Docket No. 50-443
NYN-02079

Seabrook Station
"Response to Request for Additional Information
Regarding License Amendment Request 01-12"

Request for Additional Information
SEABROOK NUCLEAR POWER STATION UNIT NO. 1
Based on Discussion with Lambros Lois July 17, 2002

FIGURE 1

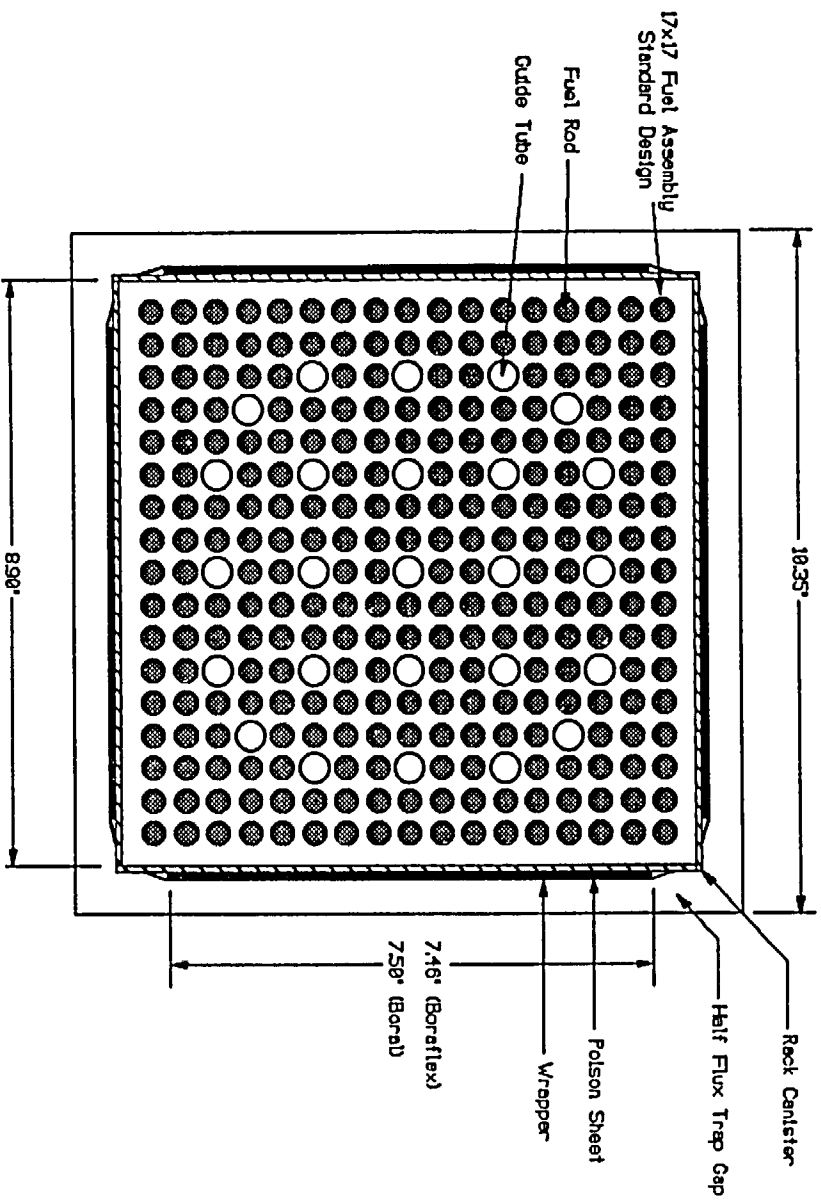
- R. Yes, the criticality analysis followed the NRC guidance.
- Q. Describe the Seabrook fuel assembly used in the criticality analysis and the empty lattice locations.

- R. The Seabrook criticality analysis used the fuel rod and fuel assembly parameters provided in Table 1. The unit cell used for the criticality analysis is provided in Figure 1. This figure provides the location of the empty lattice location (guide tube).
